**SNS-OPM-ATT 2.B-10.a.  
Unreviewed Safety Issue (USI) Evaluation Form**

Isolate Power Supply Commons in the HEBT PPS Racks and isolate HEBT/Ring Gate Control Power

The associated Permanent Change Request is documented through SNS-RAD-ICS-CR-0017 and Design Change Notice SNS-RAD-ICS-CN-0051.

Figure 1 Diagram of HEBT Power Supply Grounding. Dashed lines are wires connecting DC Common to Chassis Ground. These wires will be removed leaving the power supply DC commons isolated.

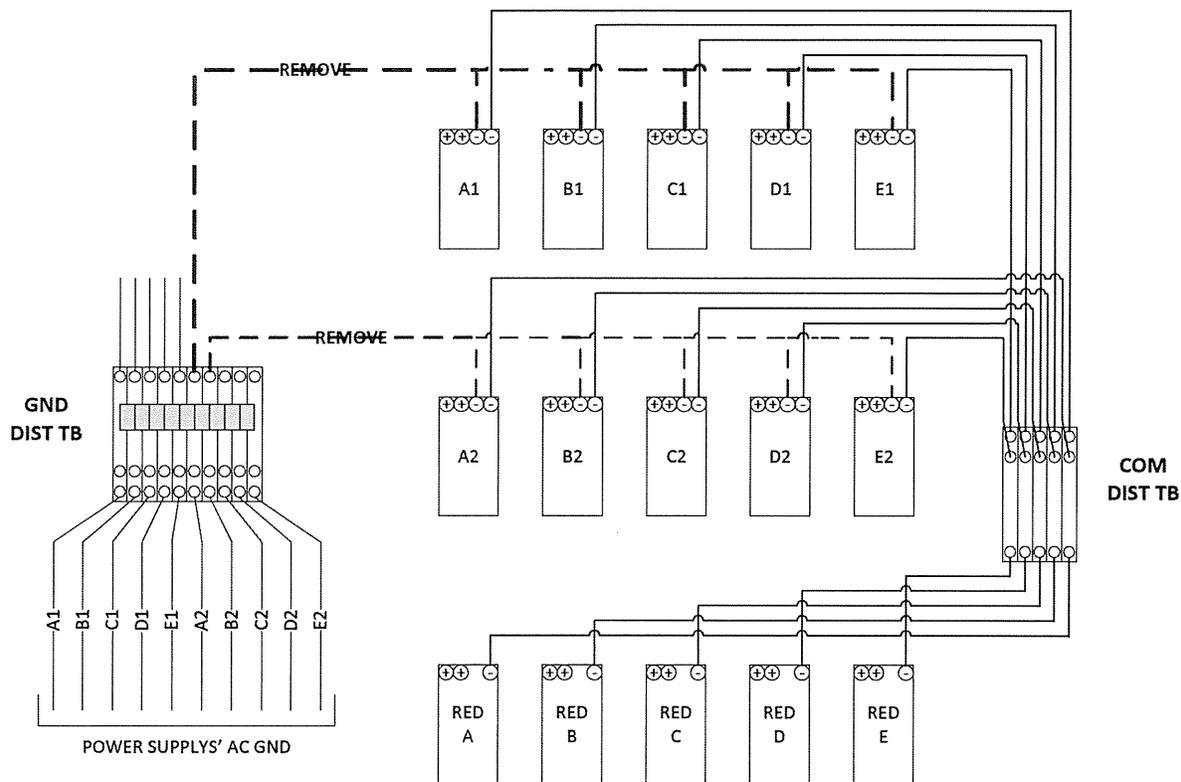
Presently, each of the DC power supply commons are connected together and to earth ground. The proposed modifications, shown in Figure 1, will remove the wires connecting the power supply commons to each other and to chassis ground. By removing the wires indicated in figure 1, each of the power supply banks will be isolated from each other and chassis ground.

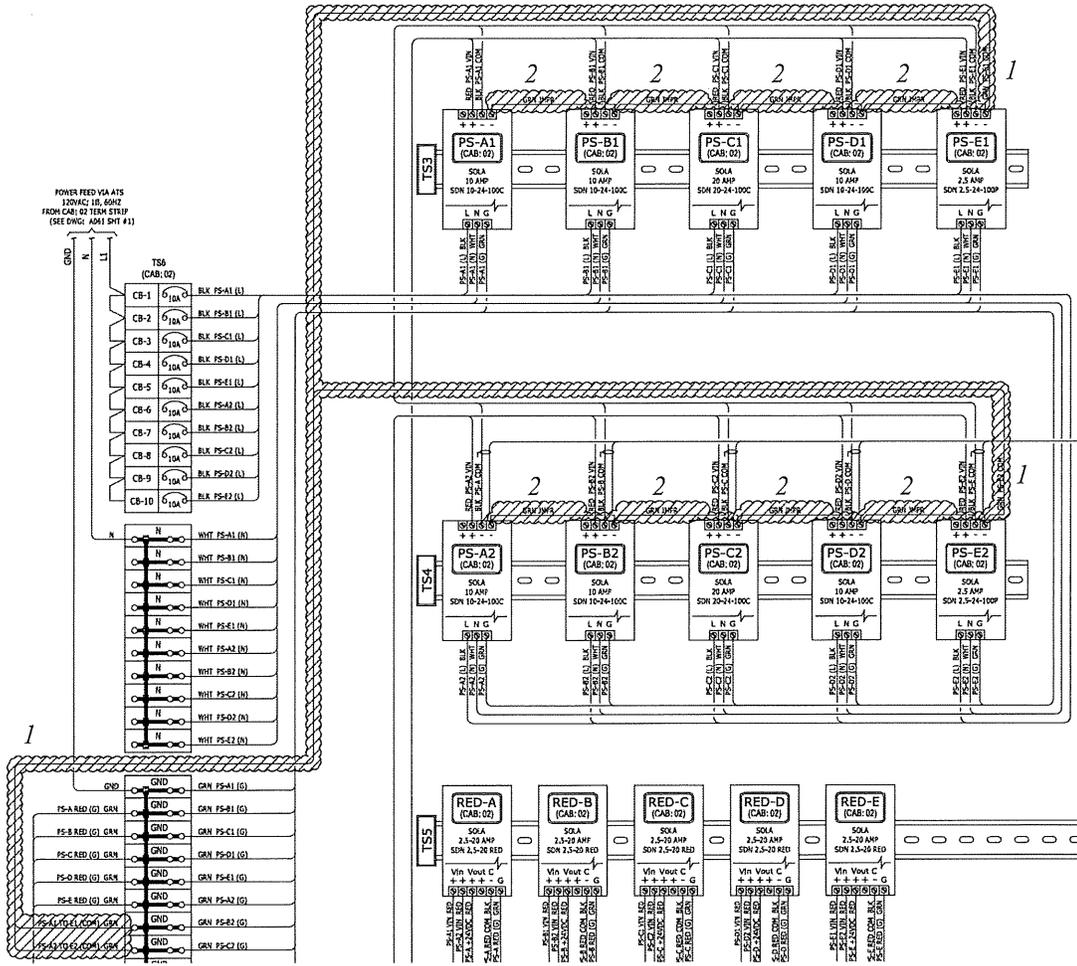
1. Remove wires that connect PPS DC power returns (commons) to earth ground.
  - a. Removing the wires connecting Power Supplies to earth ground isolates the PPS DC returns from AC ground. (See areas marked '1' Figure 2)
2. Remove wires that connect Power Supply commons for A1-E1 and A2-E2.
  - a. Removing the wires that connect power supply commons isolates the commons for each power supply bank. (see areas marked '2' Figure 2)

Figure 3 Existing gate maglock control using steering diodes. Diodes and associated wiring (dashed red lines) will be removed.

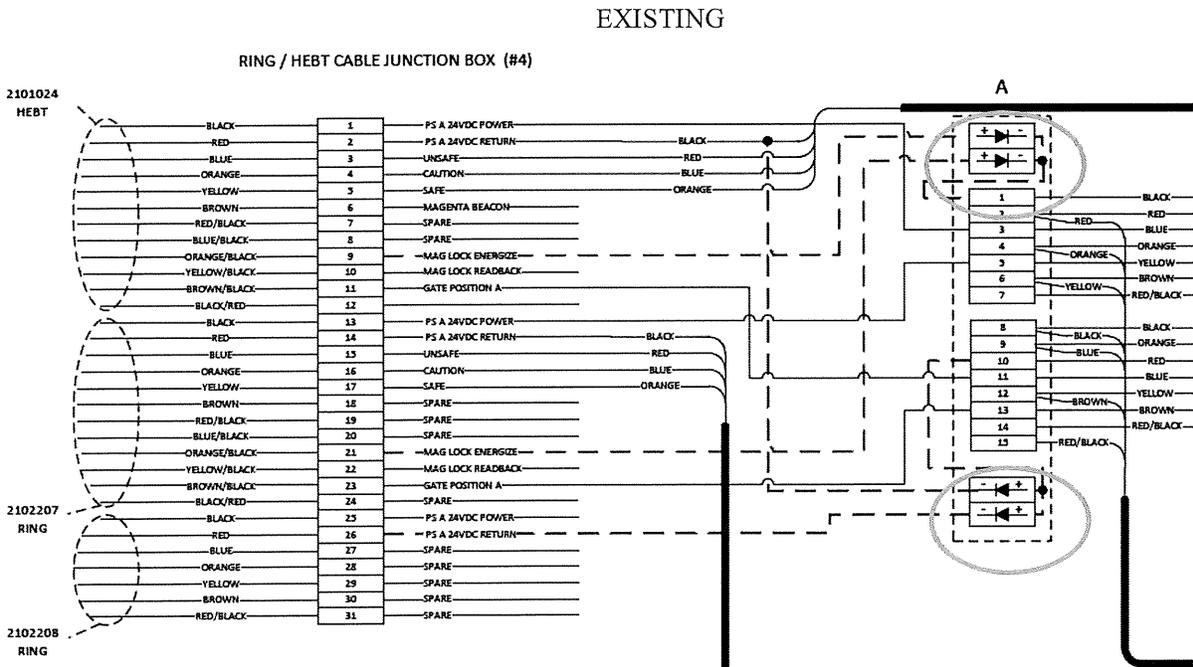
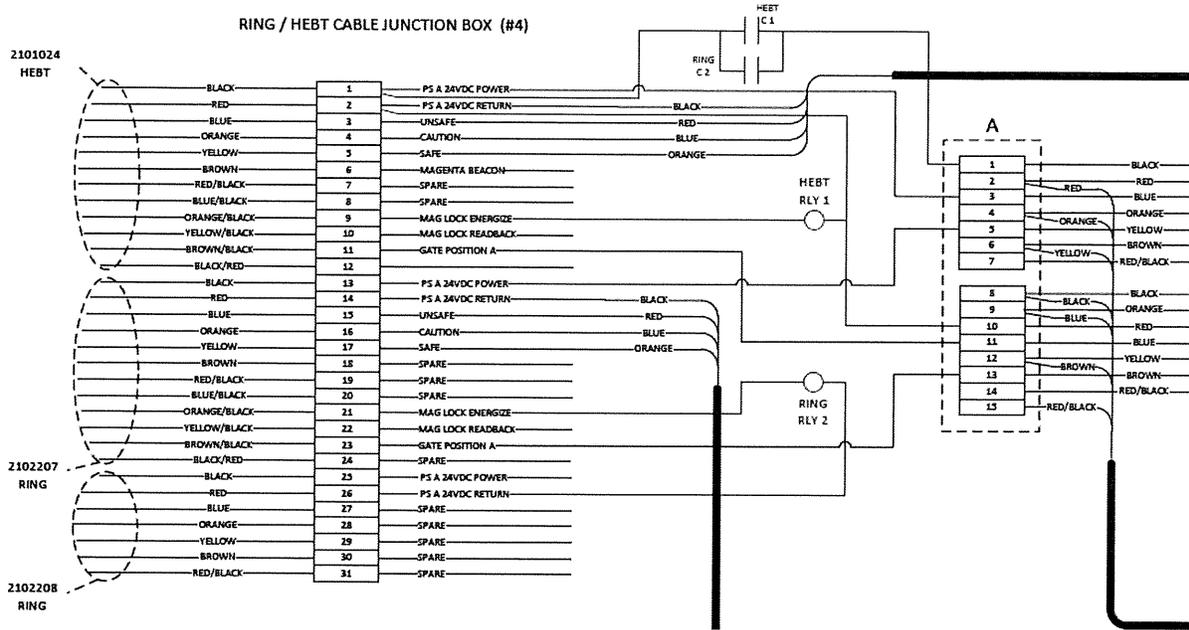
3. *Re-wire the HEBT/Ring tunnel gate junction boxes using relay logic rather than diodes to electrically isolate the gate magnetic lock control power and returns from each other.*
  - a. Remove the steering diodes and associated wiring from the gate interface boxes. (See Figure 3)
  - b. Two relays will be installed to isolate the HEBT maglock control power from the Ring maglock control power. The gate control contacts are arranged as a logical 'OR' where either the HEBT or the Ring PPS can lock the gate. Figure 4 shows the modified gate maglock control wiring with relays used for isolation between the HEBT and Ring PPS systems.

Figure 5 Modified gate maglock control using relays for isolation. Red lines show relays and new wiring. HEBT and Ring magnetic lock control power and returns are now galvanically isolated.
